## 4 Motivation for NG-EPON

### 4.1 Background and market drivers

Figure 12: Peak-hour bandwidth headroom = maximum service level that can be offered for existing and NG-EPON candidate access technologies in year 2024 (≠32 subscribers per PON).

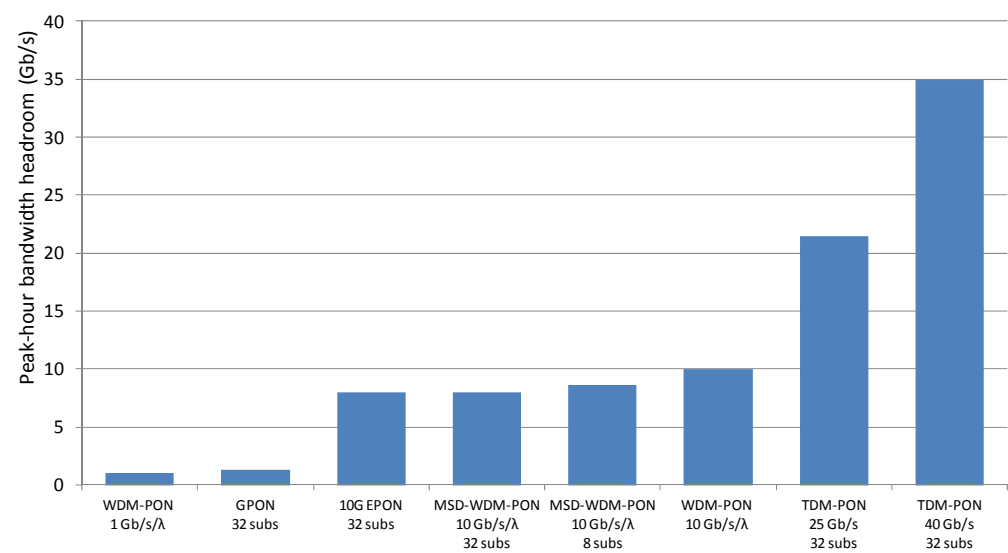
Commented [MH7]: Lots of unnecessary words – we need to state just facts we observe based on the model: 10G-EPON is sufficient until 2024 (likely) and then blend in Figure 12 and conclusions from it.

Figure 13: Maximum permitted bandwidth for cable modems [XXX]

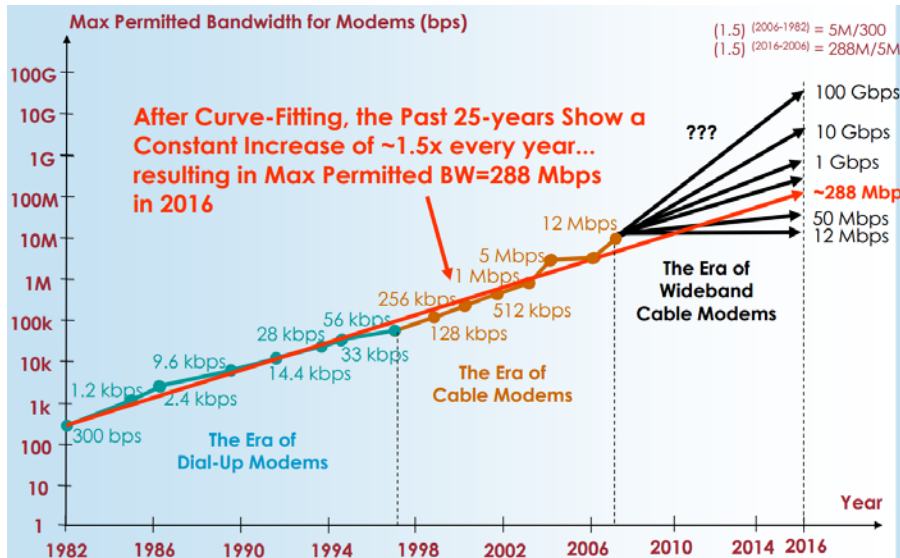
Commented [MH9]: Make sure that the cable modems are just an example here for other devices.
